Submittal Contents:

Resident Storage Locker Submittal
154 storage lockers provided; 153 lockers shown in plan.

WESLEY HOMES

DWN BY: FB	DATE: 02/24/2020	MADE FROM:	SHEET: 1 of 3
APPD BY: NTS	SCALE:	CAD FILE: 8492	DWG NO: 8492

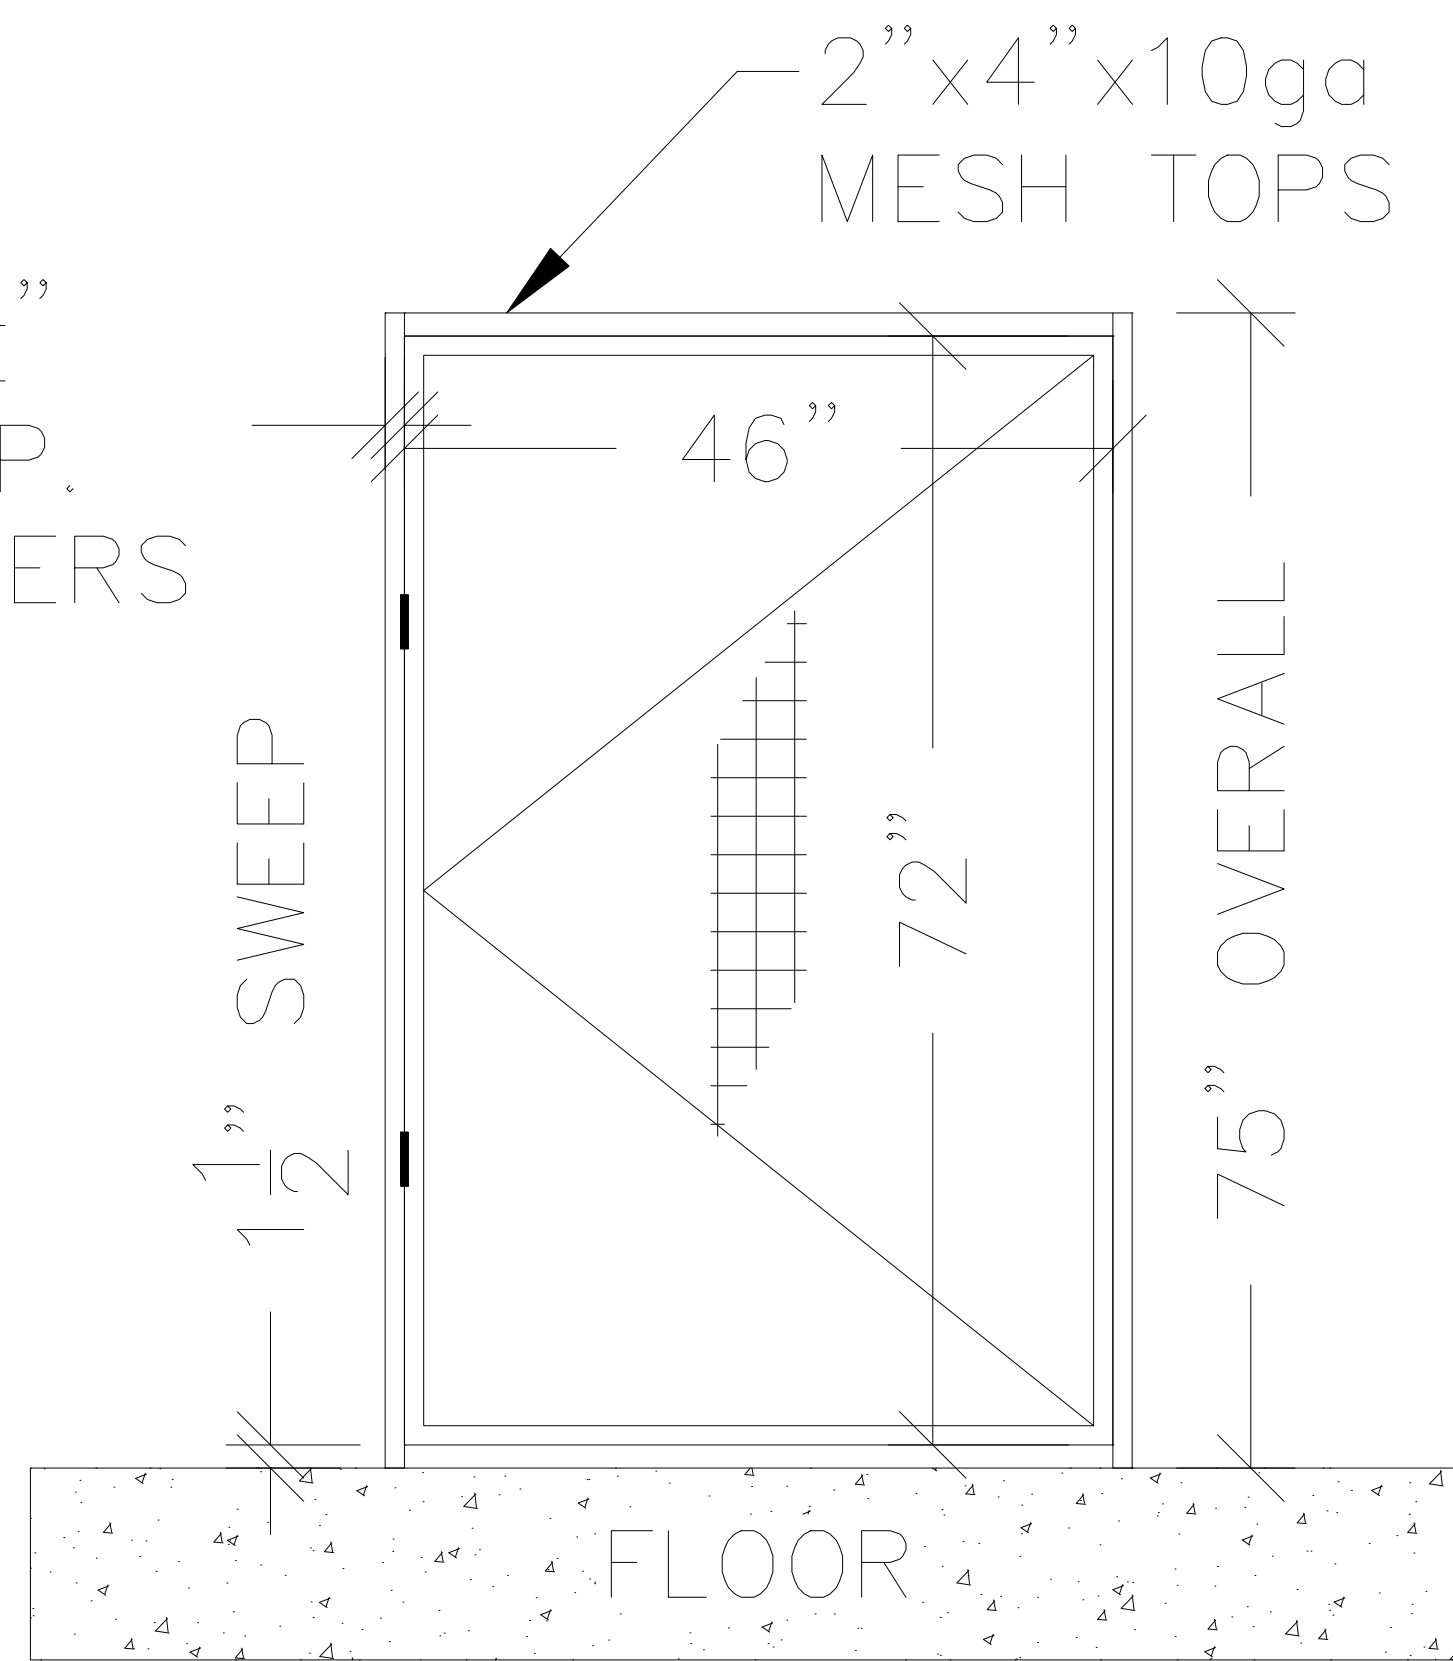
(1) locker shown in plan with an ADA circle, (0) shown that way in these shops, AOR please confirm if any ADA lockers are required.

DOORS SHALL PROVIDE 32" CLEAR, TYP

PER ANSI A117.1 2009, A TURNING SPACE IS NOT REQUIRED IN STORAGE ROOMS/LOCKERS THAT ARE LESS THAN 48". PER THE COMMENTARY, THE 48" CAN BE MEASURED FROM WHERE SOMEONE WOULD MOVE INTO THE CLOSET. ASSUMING ITEMS ARE STACKED IN THE BACK, THE STANDARD LOCKER MEETS ADA REQUIREMENTS. THEREFORE, DUE TO THE VAST NUMBER OF LOCKERS MEETING ADA, SPECIFIC ADA LOCKERS NEED NOT BE DESIGNATED

DWN BY: FB	DATE: 02/24/2020	MADE FROM:	SHEET: 2 OF 3
APPD BY:	SCALE: NTS =	CAD FILE: 8492	DWG NO: 8492

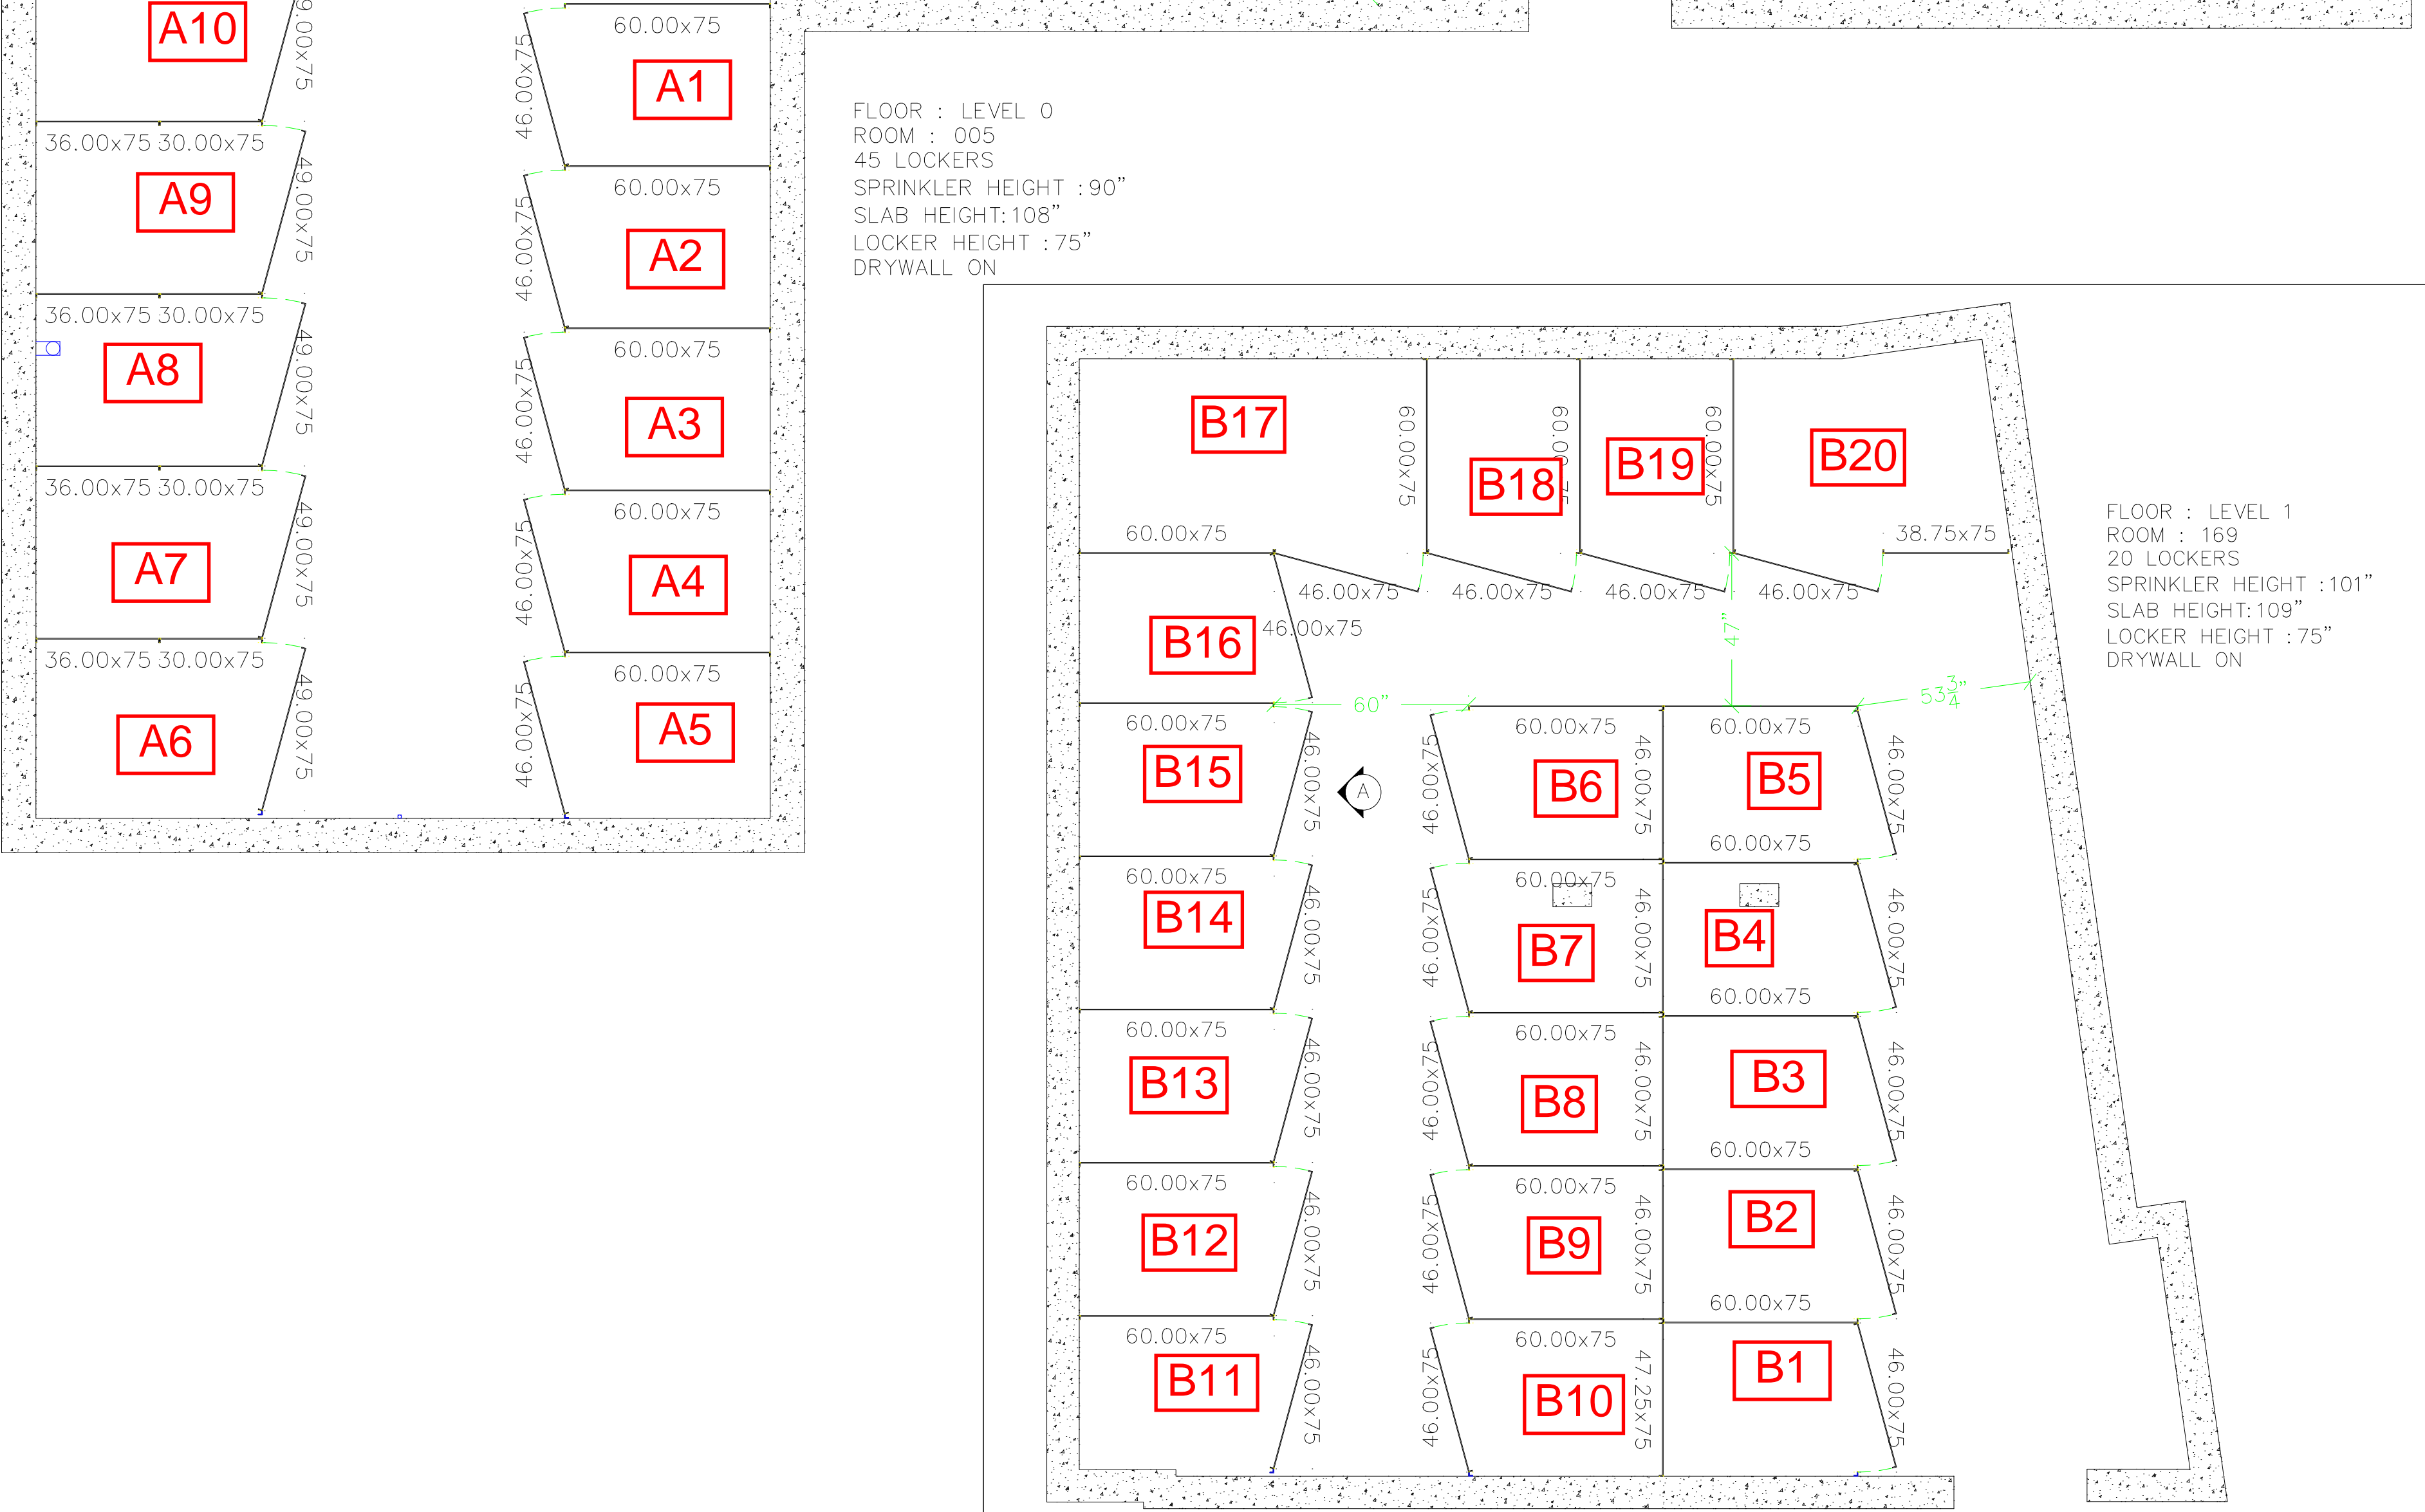
NUMBERS NOT
 EDITED ARE OK
 EXCEPT ADD 'C'
 SIMILAR TO THE
 EDITED ONES

A1.00B-GARAGE LEVEL PLAN EAST

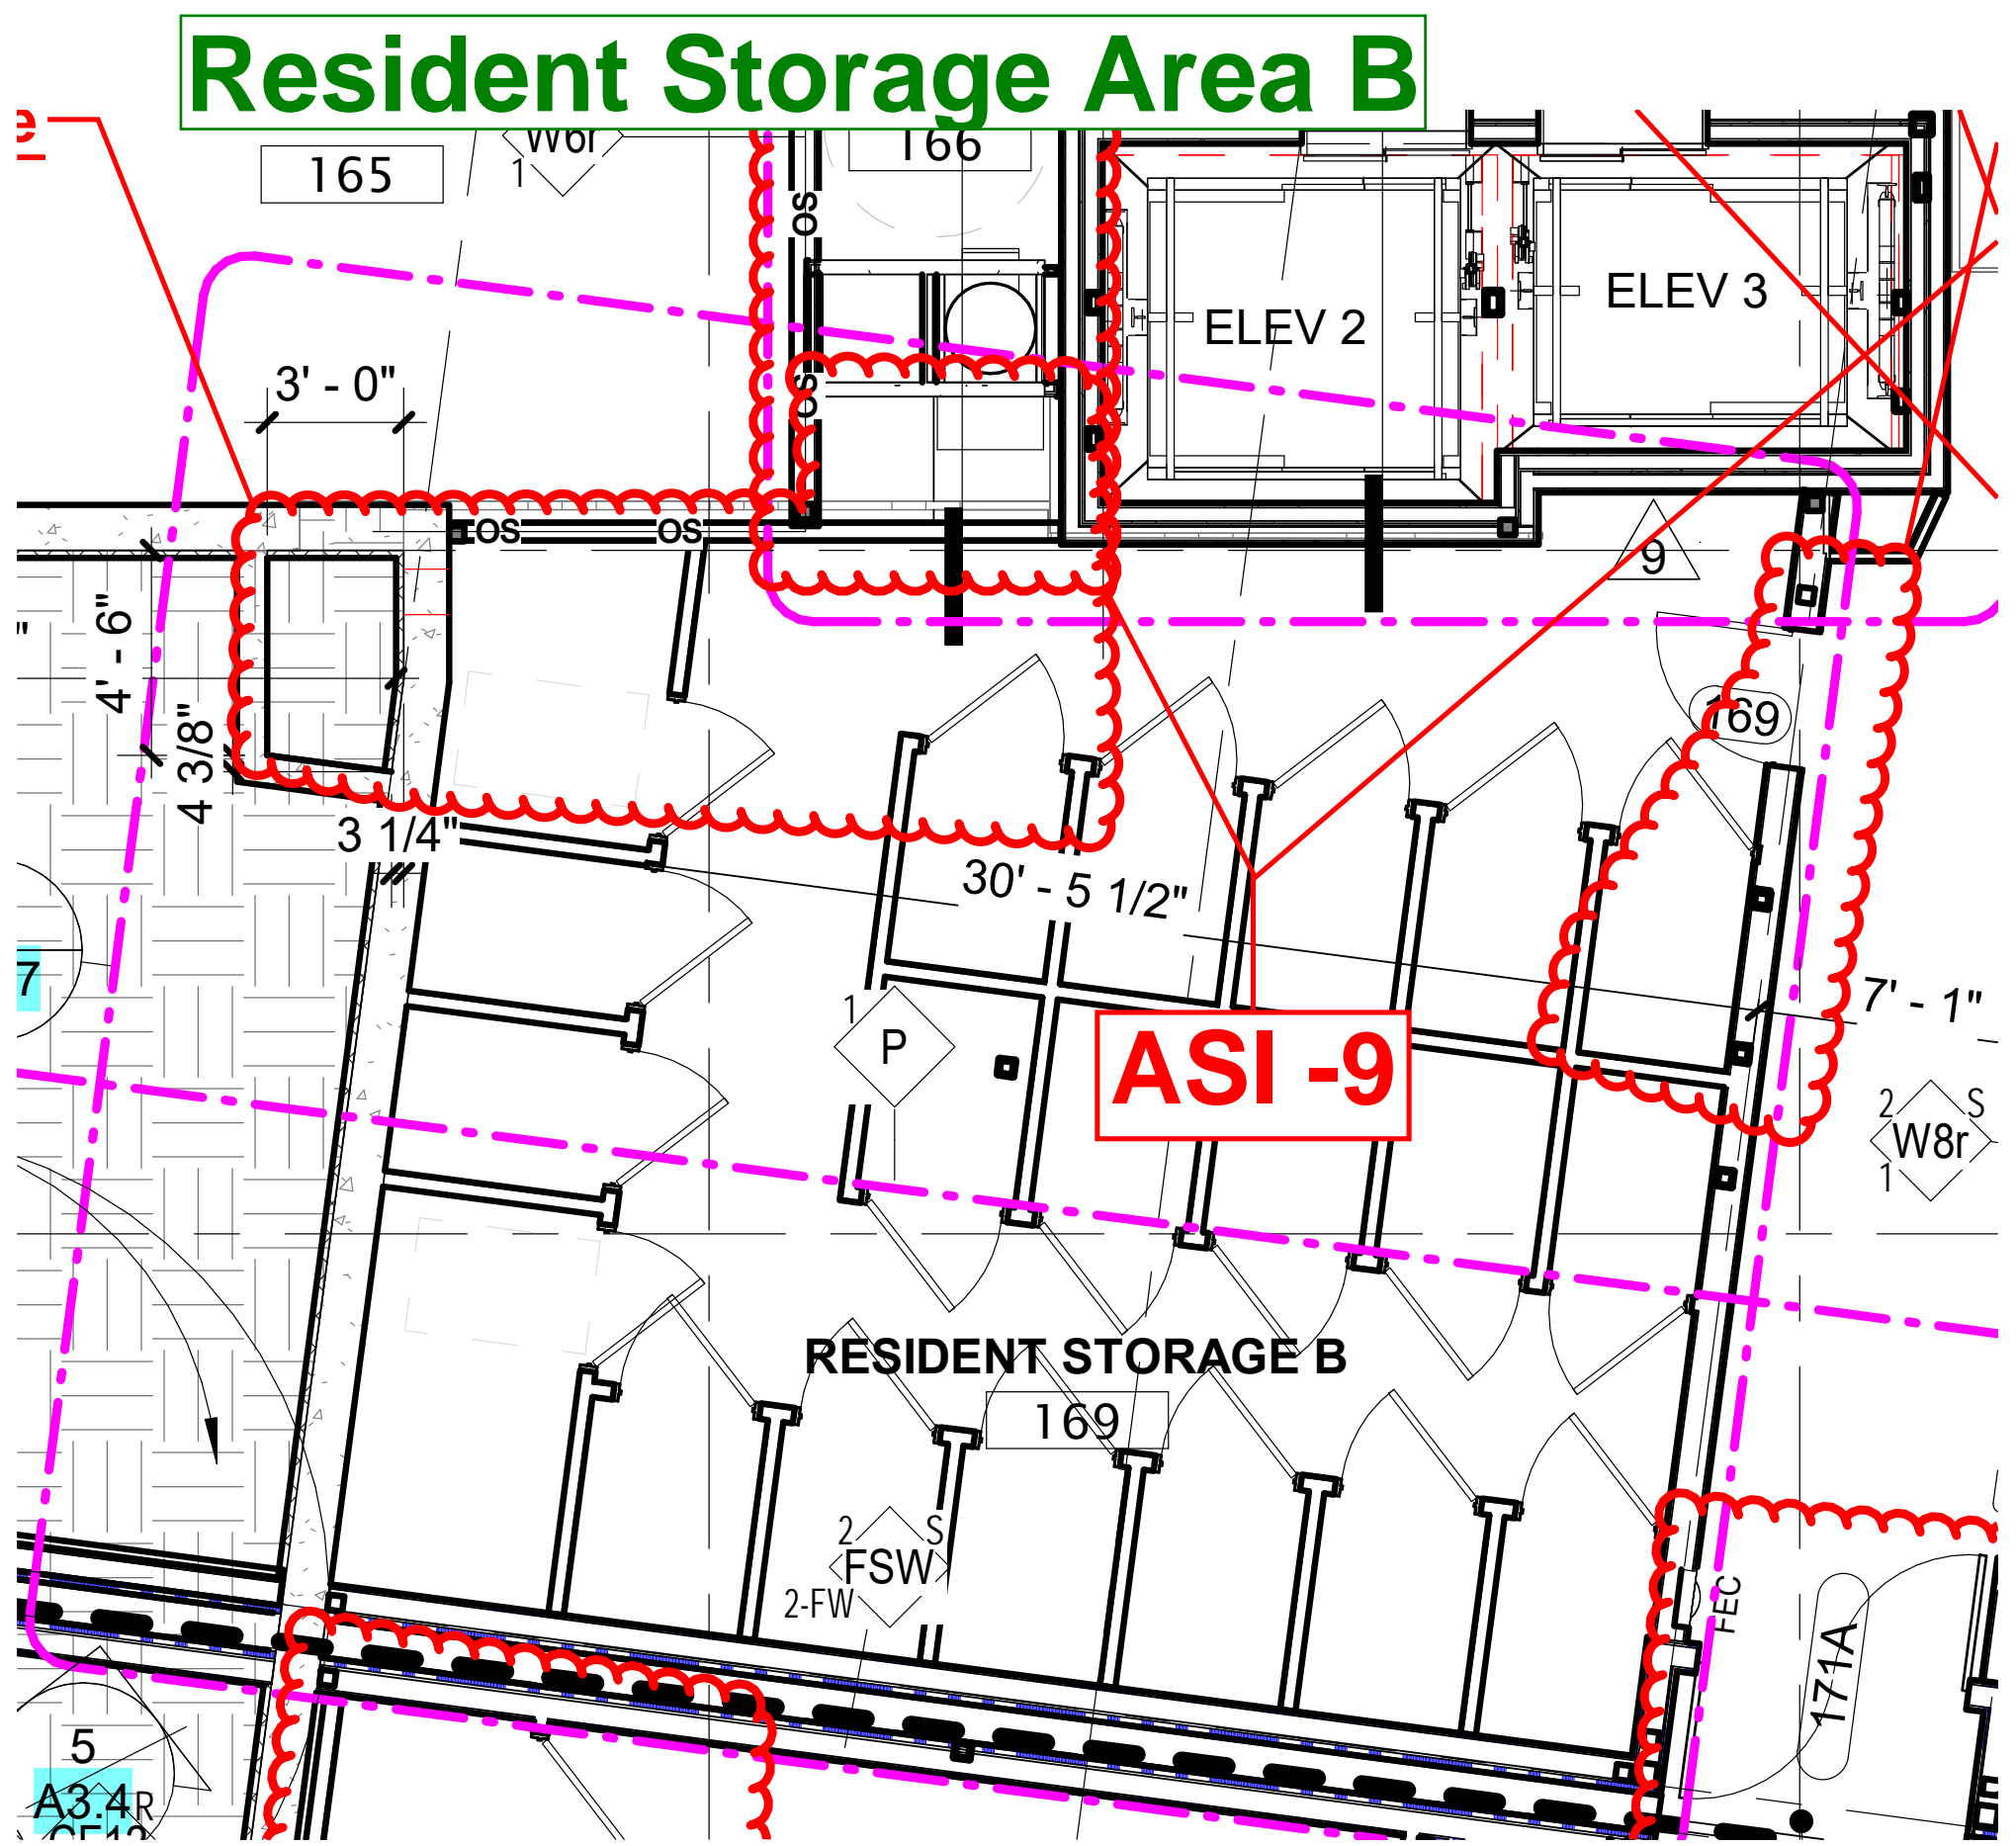
Arch. pages with storage lockers (153 count) pasted in for easy reference
